Access Compliance Report Public Rights-of-Way (Curb Ramps)

Main Street: SIENNA_PKWY		Cross Street: DORRANCE_DR		Location:	S
ADA ID: RPRK211110124525	Ramp Type: Type 1 - Perpendicular	Initial Pass/Fail: Fail	Overall Compliance: No	Severity Score:	15

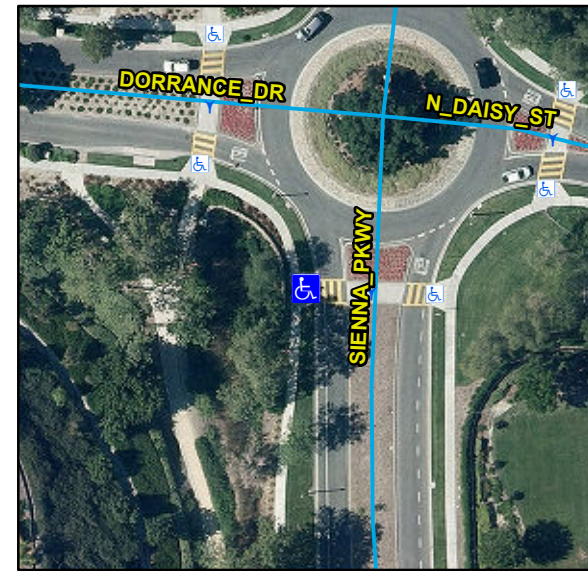
Codes/Mitigation Info/Possible Solution		Field Measurements/Component Compliance	
---	--	---	--

Compliance	Description	Data	Compliance	Description	Data
N/A	Ramp Length (in)	89	N/A	Flare Type LT	
Yes	Ramp Width (in)	48			N/A
No	Ramp Run Slope (%)	8.8	N/A	Flare Slope LT (%)	N/A
Yes	Ramp Cross Slope (%)	1.2	N/A	Flare Traversable LT	N/A
N/A	Landing Present	N/A	N/A	Flare Type RT	
N/A	Landing Length (in)	N/A			N/A
N/A	Landing Width (in)	N/A	N/A	Flare Slope RT (%)	N/A
N/A	Landing Run Slope (%)	N/A	N/A	Flare Traversable RT	N/A
N/A	Landing Cross Slope (%)	N/A	N/A	DWS Provided	N/A
N/A	Landing Movement Obstructed?	N/A	N/A	DWS Contrast	N/A
	Landing Movement Type	N/A	N/A	DWS Length (in)	N/A
N/A	Landing Shared	N/A	N/A	DWS Full Width	N/A
N/A	Clear Space	N/A	N/A	DWS Offset Left (in)	N/A
N/A	Clear Space To Crosswalk (in)	N/A	N/A	DWS Offset Right (in)	N/A
N/A	Marked Crosswalk 1	Yes	N/A	Marked Crosswalk 2	N/A
	Crossing 1 Direction	E		Crossing 2 Direction	N/A
	Marked Crosswalk 1 Width (in)	144		Marked Crosswalk 2 Width (in)	N/A

N/A	Ramp Inside Crosswalk 1	Yes	Yes	Ramp Inside Crosswalk 2	N/A
	Crossing 1 Slope (%)	1.9		Crossing 2 Slope (%)	N/A
	Crossing 1 Cross Slope (%)	1.4		Crossing 2 Cross Slope (%)	N/A
N/A	Gutter Ponding	N/A	No	Curb Slope	8.3
Yes	Gutter Lip Height (in)	0		Road Run Slope (%)	N/A
N/A	Gutter Run Slope (%)	N/A		Road Cross Slope (%)	N/A
N/A	Gutter Cross Slope (%)	N/A			
Yes	Overall Surface Condition: Acceptable		Yes	Perp Joint Present	Yes
	Cross Gutter Present?	No		Spandrel Present?	No
	Replace Cross Gutter?	N/A		Replace Spandrel?	N/A

Remove & Replace Entire Ramp.

R304.2.2, STD 1115
